TESTIMONY
of the
STATE OF UTAH
REGARDING THE DEPARTMENT OF ENERGY'S
IMPLEMENTATION OF THE NUCLEAR WASTE POLICY ACT OF 1982

HOUSE COMMITTEE ON
INTERIOR AND INSULAR AFFAIRS

October 8, 1984

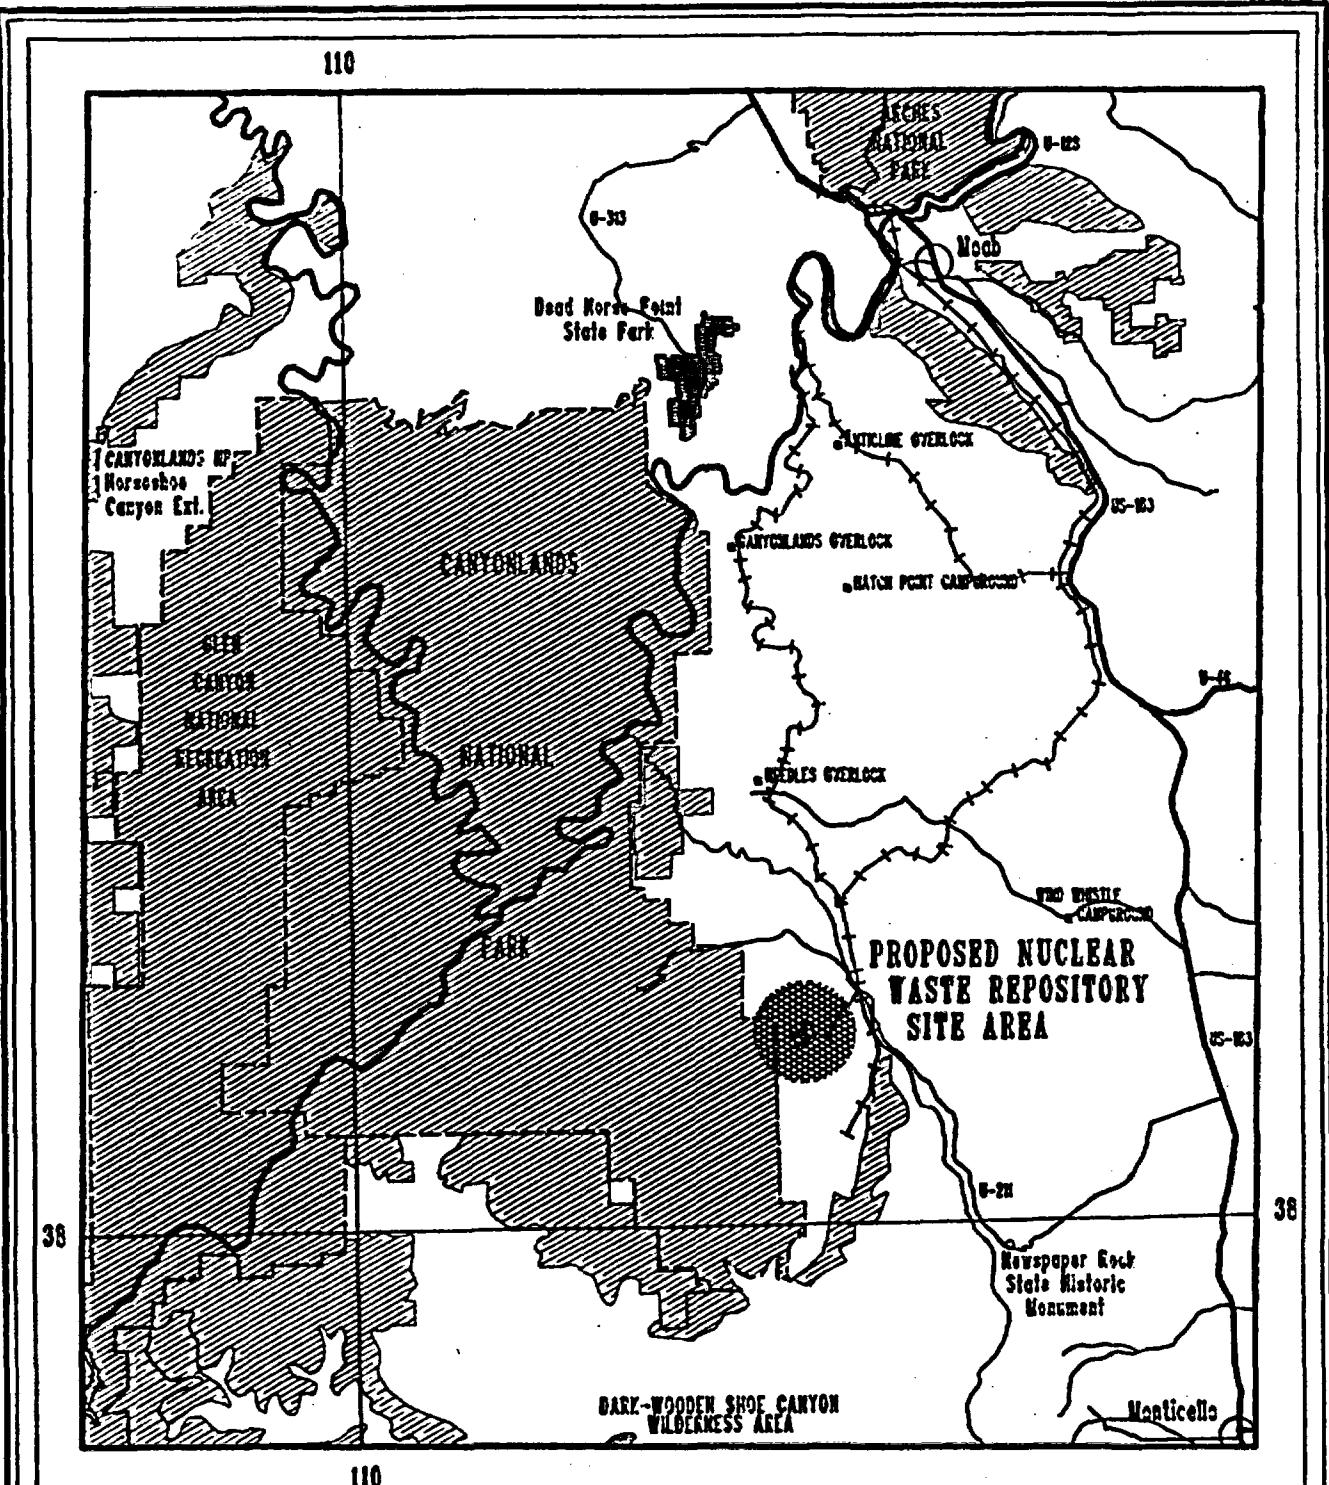
The potentiometric levels and directions of groundwater flow for the 3 preliminary hydrostratigraphic units identified are based once again on extrapolation of the data obtained from oil and gas exploration boreholes in the region. At best, the assumptions made are tentative. The nearest datum for the lower hydrostratigraphic unit are about 40 miles south of the sites and about 80 miles to the southwest. The potentiometric surface drawn between such distant points is of very limited value in making determinations of groundwater levels and flow directions.

DOE's use of non-committal phrases to describe the geohydrology of the sites only serves to highlight the uncertainties involved and confuse interested members of the public. In the working drafts of the Environmental Assessments and supporting documents, there are alarmingly frequent uses of phrases such as "probably is", "thought to be", "may be", "tentatively is", "assumed to be", "estimated to be", "appears to be", "as presently defined" and "apparently is". These phrases are predicated on insufficient data.
